City of Biddeford
Historic Preservation Commission

HISTORIC PRESERVATION COMMISSION REPORT

RE: **Item 3.1: 2025.29 HPC Review** Kris Samaras to install select new replacement windows at 247 Elm Street, Tax Map 34, Lot 43, in the MSRD-2 Zone.

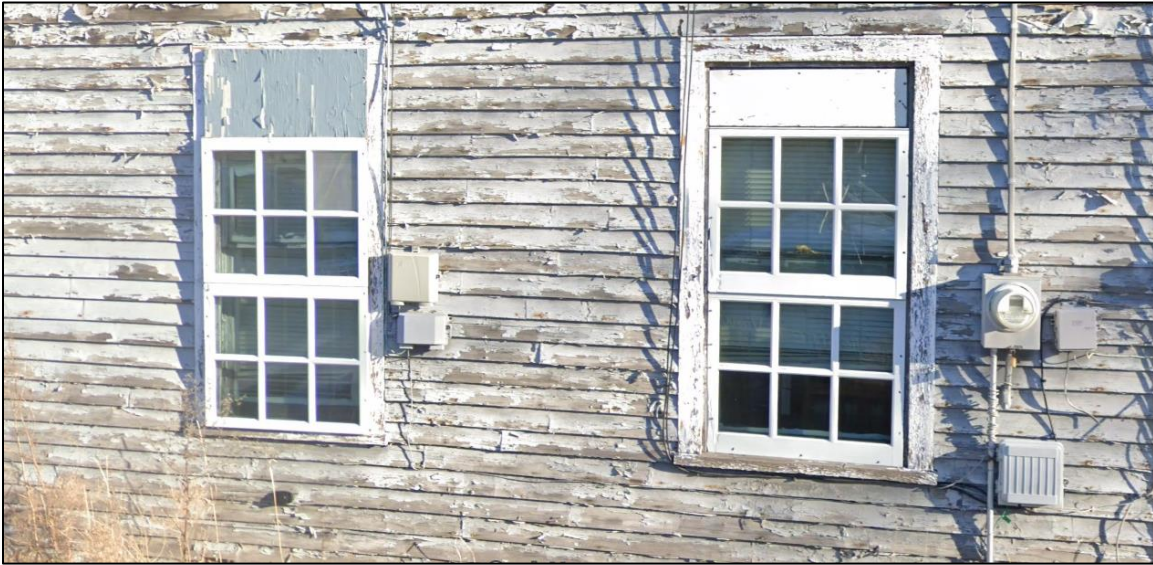
The front windows and basement windows at the side appear to be in poor condition:

The window openings at the side are fitted with two fixed units and a filler panel at the head of each opening, instead of a proper operating window unit.

Much of the integrity of this building appears to be intact. The siding, trim, doors and steps are of historic materials. Most windows, however have been replaced with vinyl. Of special consideration, as depicted above, are the two windows at the front of the building facing Mason Street. Currently each are made up of two ill-fitting fixed units attached into the existing opening. Installing a proper double hung until will be an improvement over current conditions.

Profile of the proposed Paradigm windows do not match the profile of existing windows.

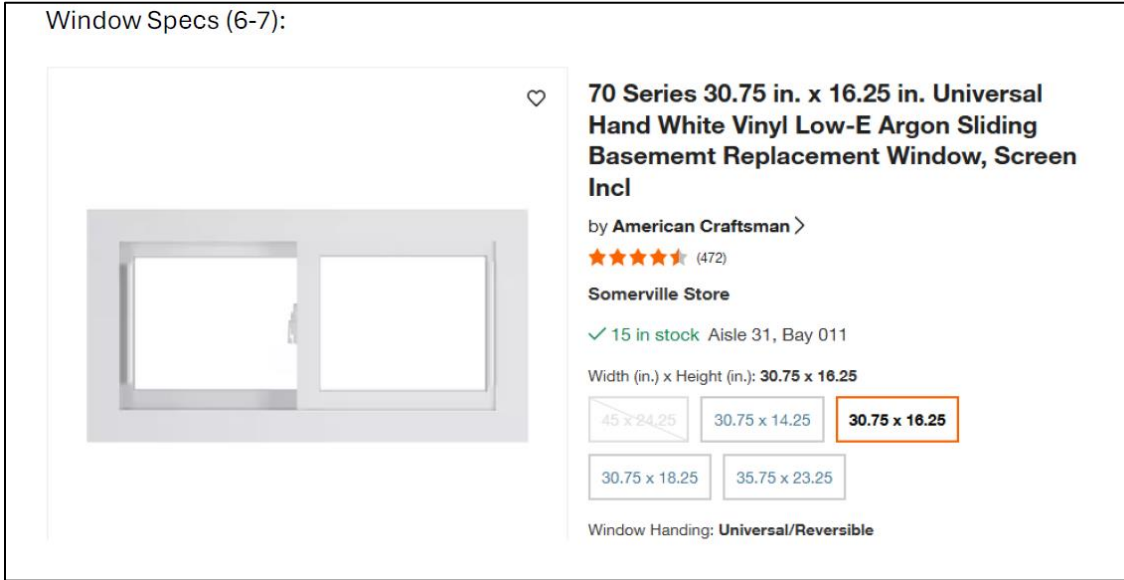
No grille pattern is proposed for the new double hung units.

New vinyl windows will match existing windows in design, composition and other visual qualities. However, profile of new windows will not match existing. Existing windows have no grille pattern, nor will the proposed replacement windows.
